Upstarts Draft 0.15 Review

Jerry Hauck

Zayante, Inc.

12/30/98

4.1.2 Sending_tone question

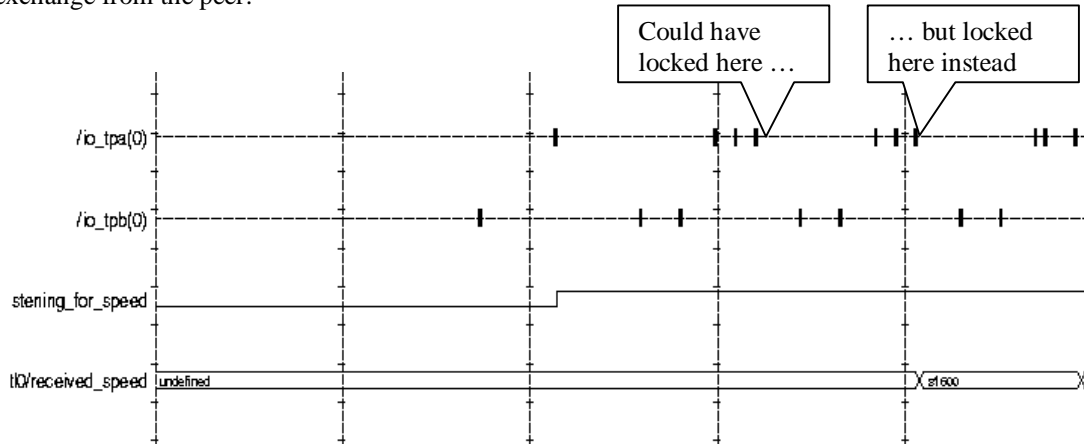
Why does bias_status return when sending_tone is TRUE? It seems this should be done on a port by port basis; i.e. sending_tone[i] should be tested. Was it intentional to abandon all bias processing if any given port was toning?? Also, if we are toning on a given port, should the bias_filter bit or the time interval be reset???
